Alton Coal Development, LLC

**Re: Coal Hollow Mine and North Private Lease Bond Adjustment Permit
Amendment, Alton Coal Development, LLC, Coal Hollow Mine, Kane
County, Utah, C/025/0005 Task ID #5916**

Alton Coal Development, LLC (ACD) is submitting this response derived from deficiencies received in Task ID # 5916 for an amendment to the MRP to adjust the calculations by which reclamation liability is determined and bonded for the Coal Hollow Mine permit areas. This adjustment is requested under Utah Code found at R645-301-830.410-430. The rules state:

DRAWING: 5-52

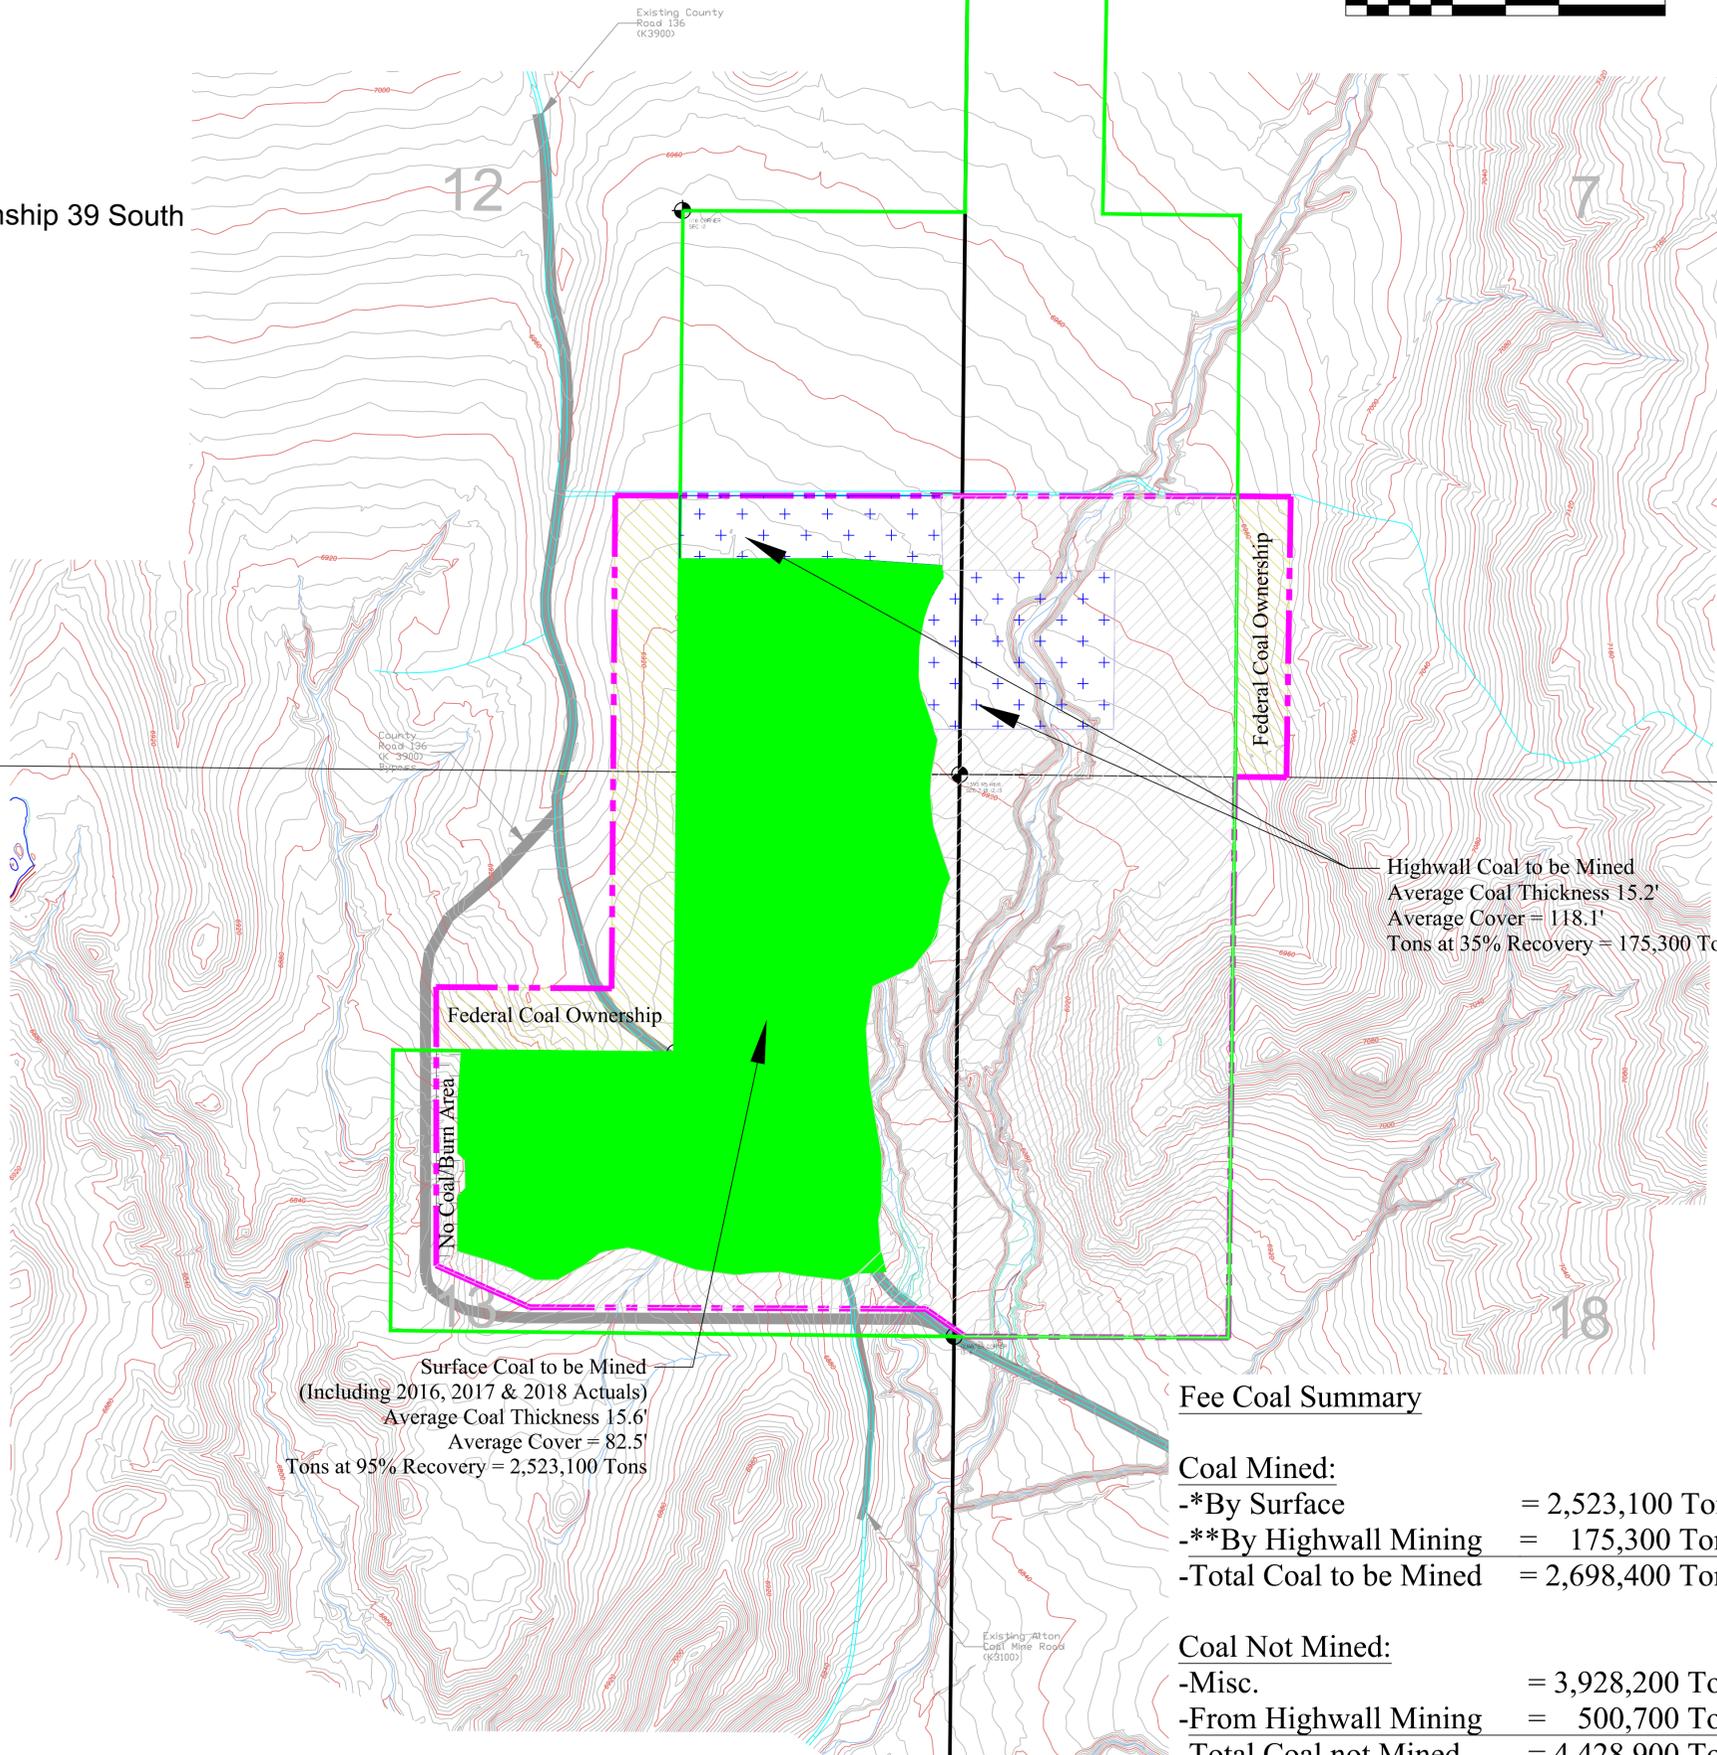
5. R645-301-521.141, R645-301-121.200: The legend in the following drawings must be updated to explain the spotted hatch pattern in old Area 3 of the North Private Lease: Drawing 5-52, Drawing 5-53, Drawing 5-57, Drawing 5-65, Drawing 5-66, Drawing 5-748, and Drawing 5-79.

DRAWING: 5-53

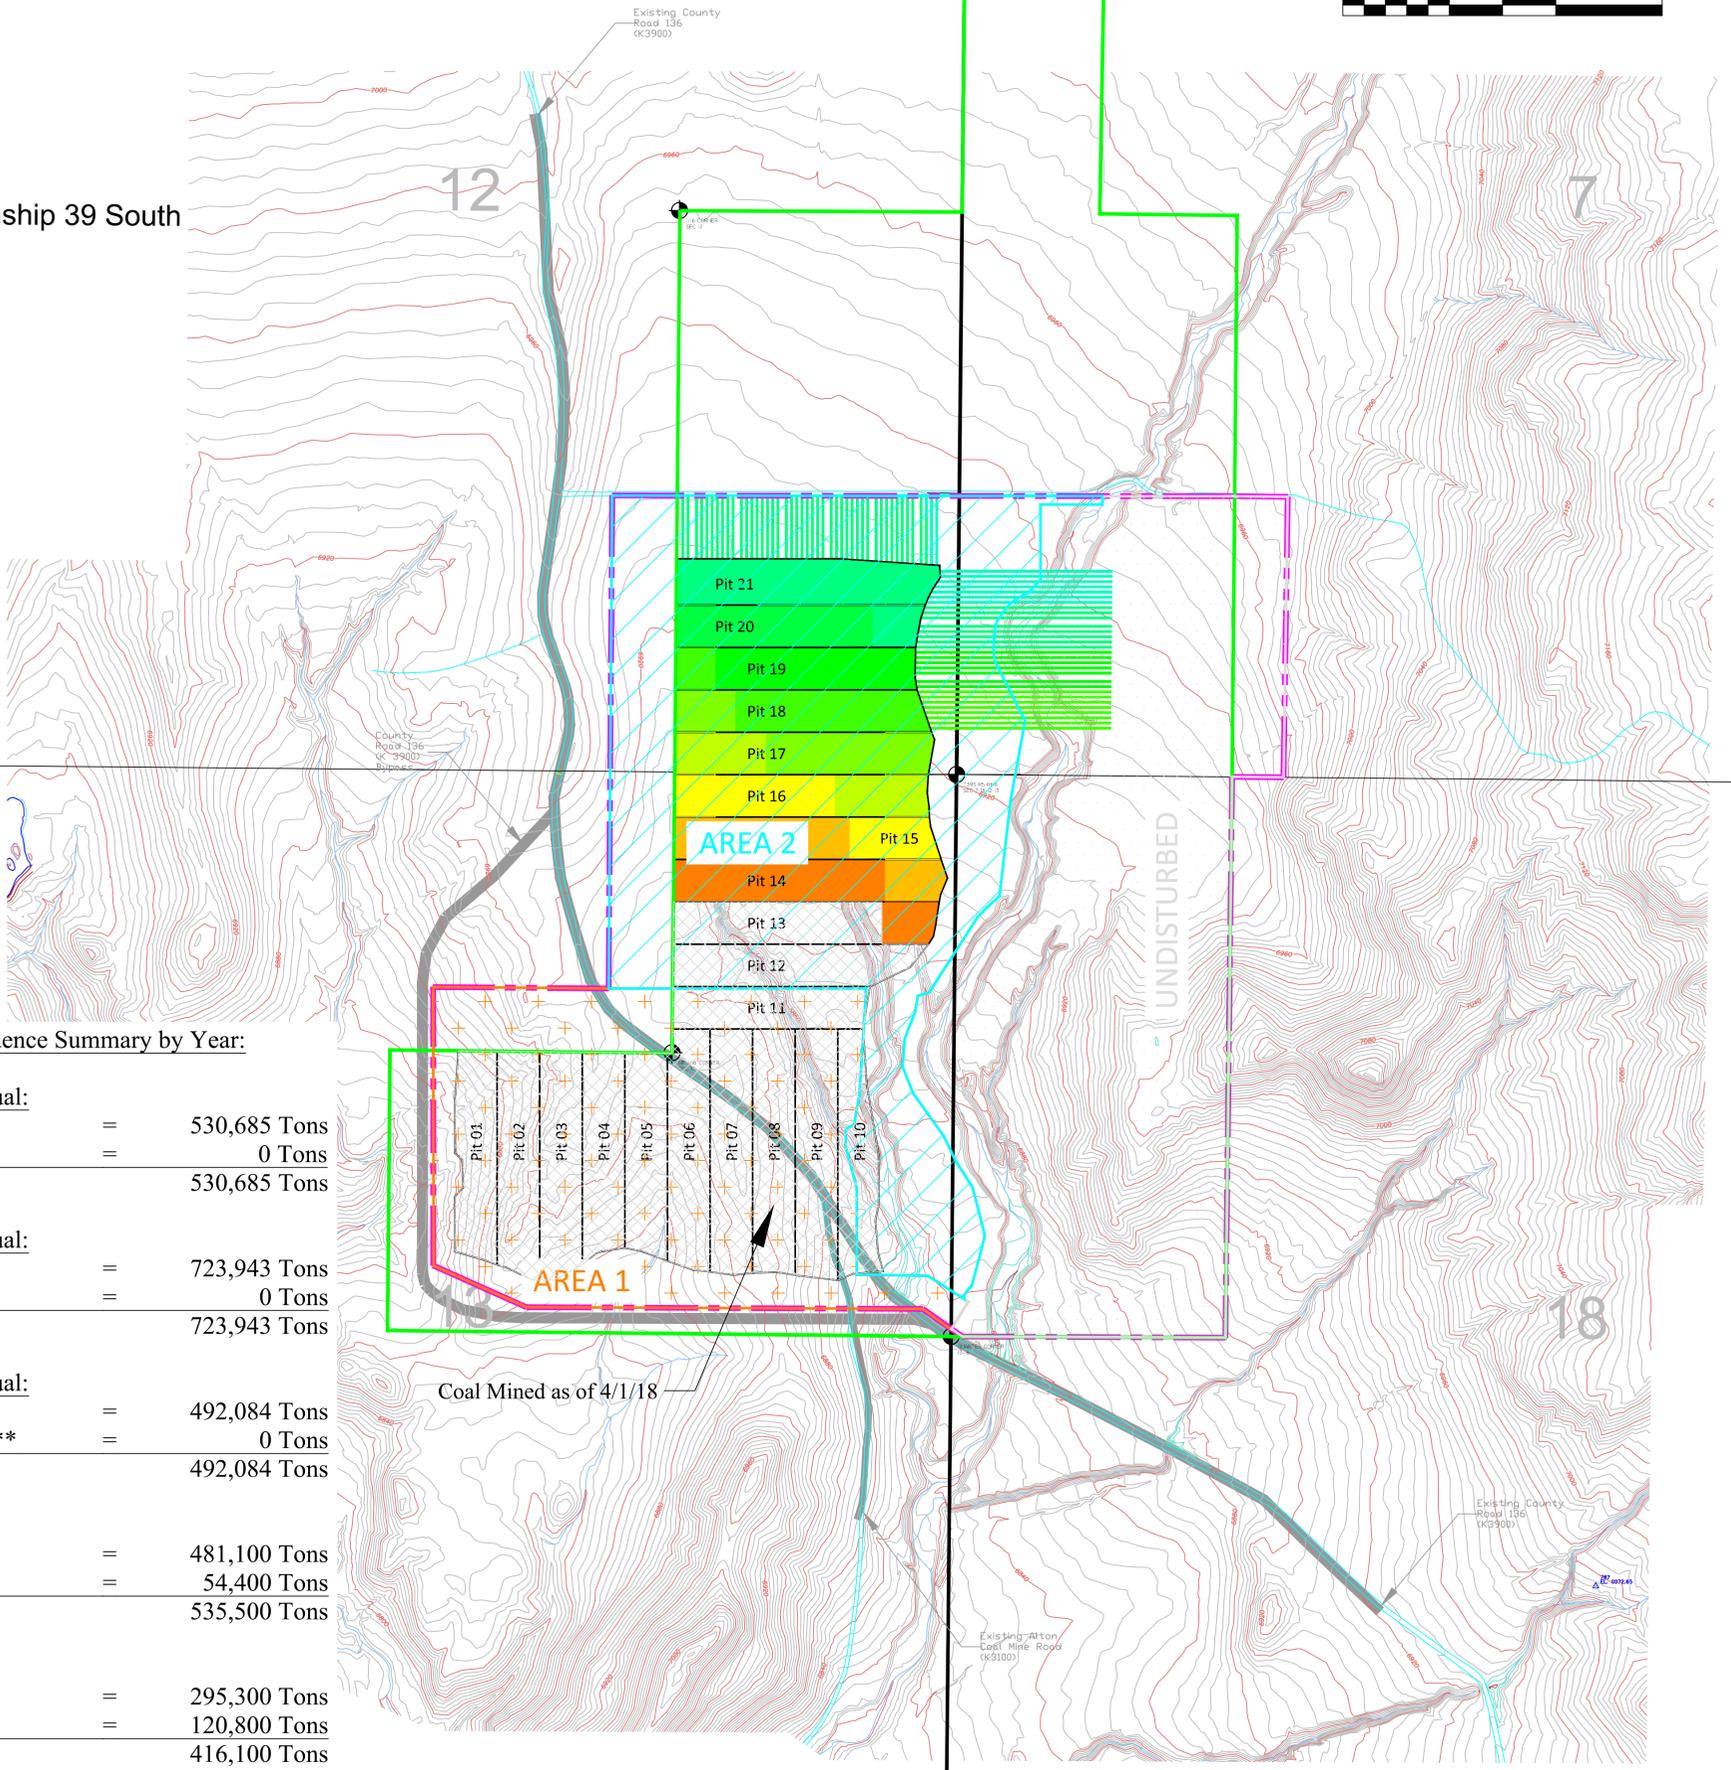
Additionally, the lines illustrating the boundaries of the Undisturbed Area 3 and Private Coal Ownership are the same color. Please change the color scheme for either one of these items in order to reduce potential confusion on the following: Drawing 5-46, Drawing 5-47, Drawing 5-53, Drawing 5-57, and Drawing 5-77.

Modified as requested

DRAWING: 5-74A

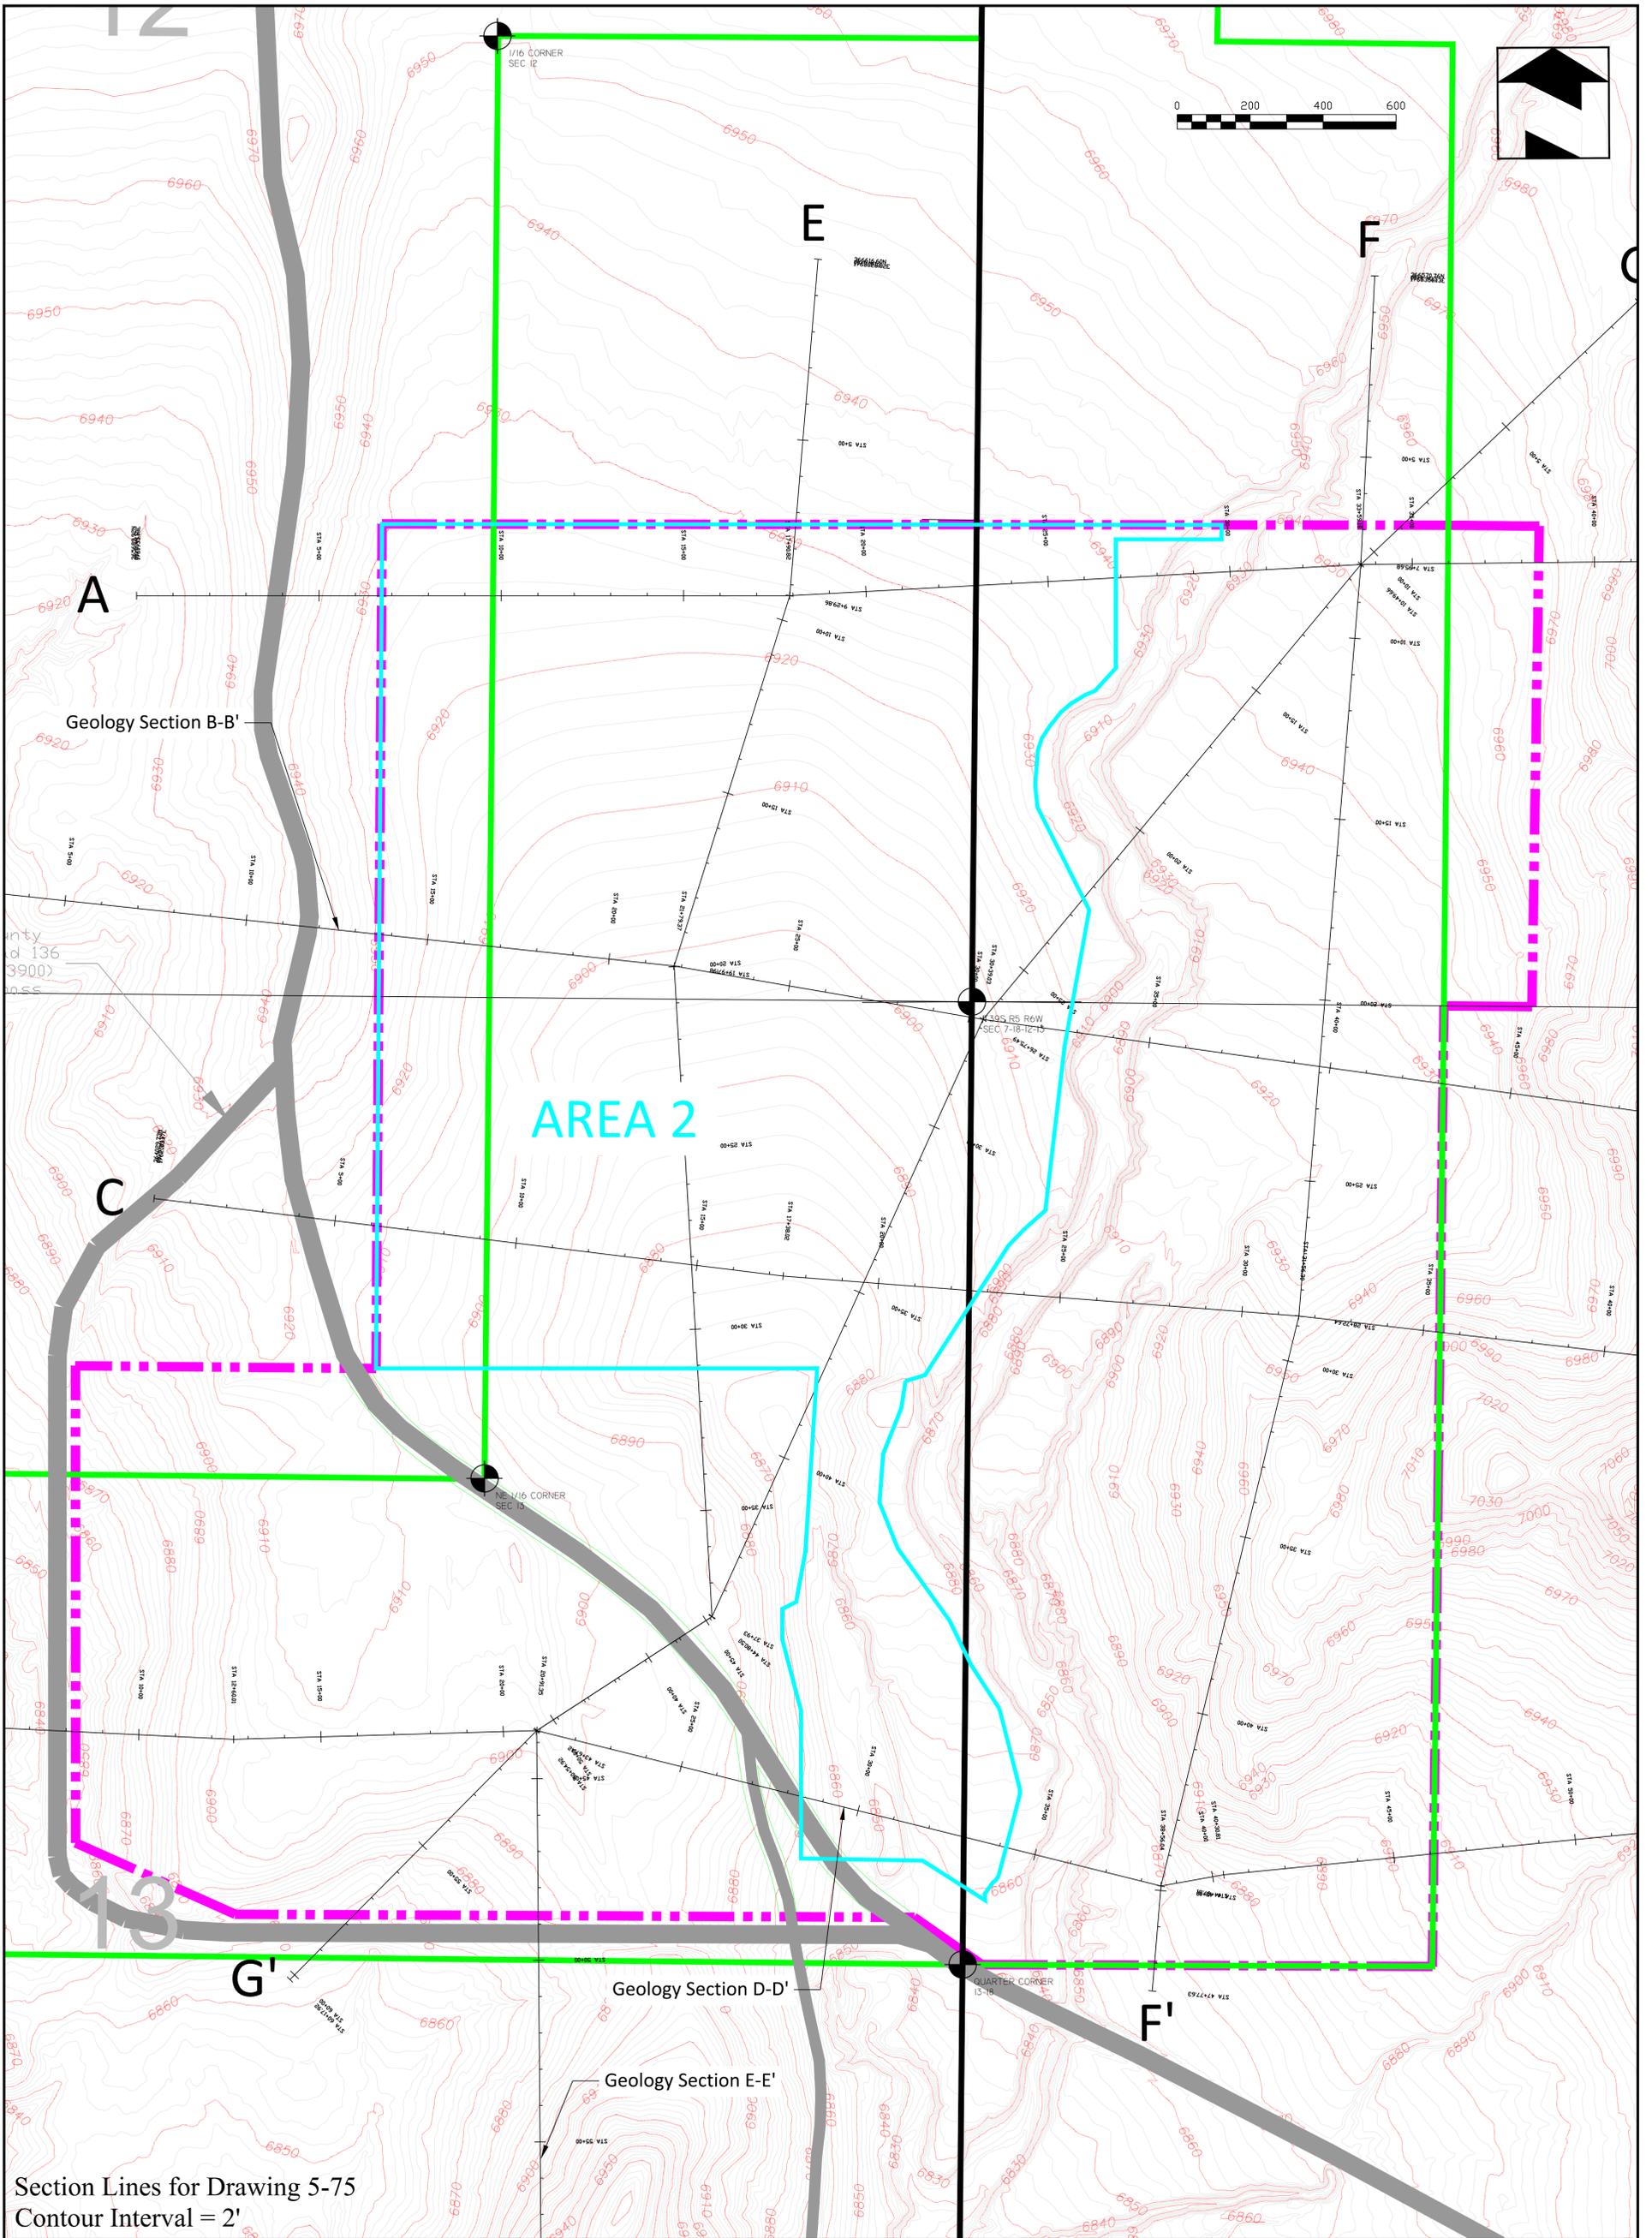
3. R645-301-121.200, R645-301-521.130: Permittee must clearly delineate the private coal ownership boundaries on Drawing 5-74A - Post Mining Topography Area 1.
